April 22, 2009

Job # 2008-17

Subject: **ADDENDUM # 1**
Front Roh Enterprises Medical Office
9441 Fenton Road, Mundy Township

SHEET TITLE
**CABINET
ELEVATIONS**

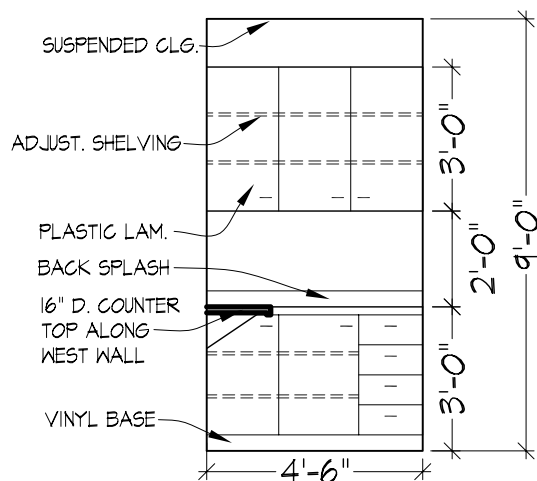
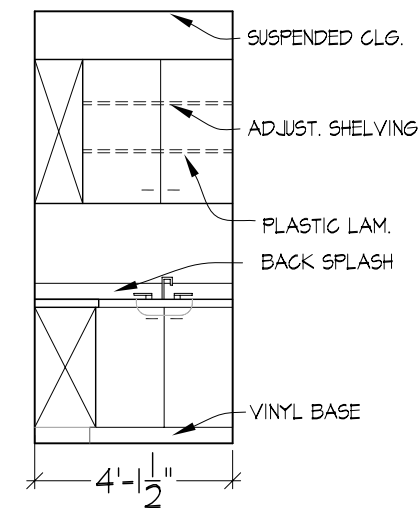
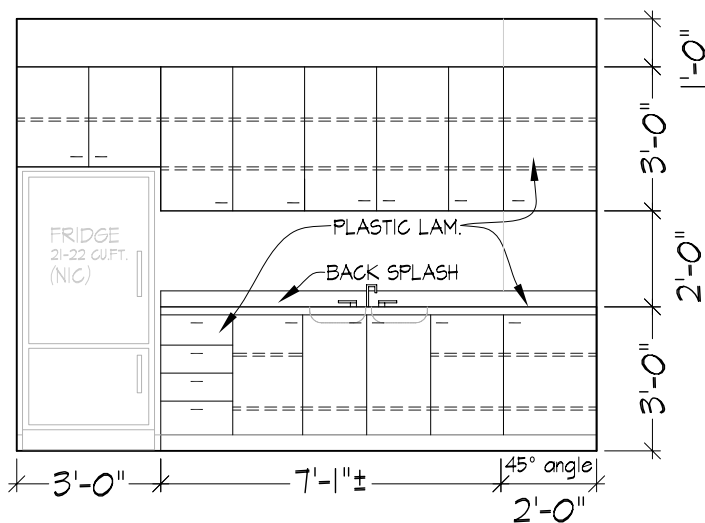
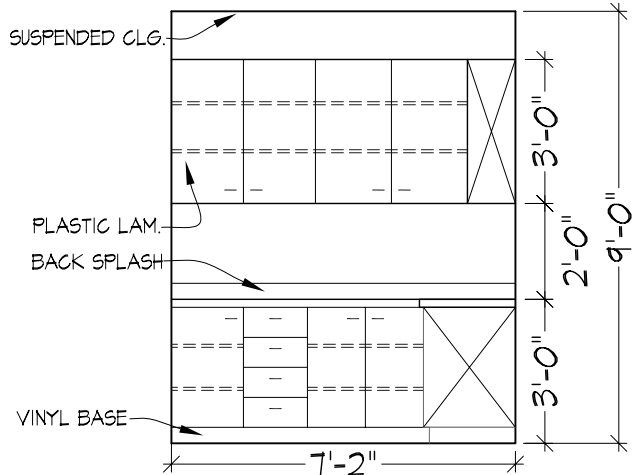
5. Sheet A3 – Exterior Elevations: Arch window trim & accent bands to be painted, color as selected by Architect.
6. Sheet A4 – Detail 4:A4 Counter height shall be 2’-6” high (note designates maximum allowed for barrier free).
7. Sheet A5 – Cabinetry Elevations: See attached drawing for additional cabinet elevations.
8. Sheet A7 – Cash Allowances
 - a. Item #1 shall be \$12,500 as per Bid Packet Cash Allowances page CA-1. Include baby changing station, Room #103, by Koala Kare or equal, surface mounted vertical, 22”w x 35.5”h x 5.25”d.
9. Sheet A7 – Division 6 – Carpentry – Attic Insulation, 12” thick Batt, R-38.
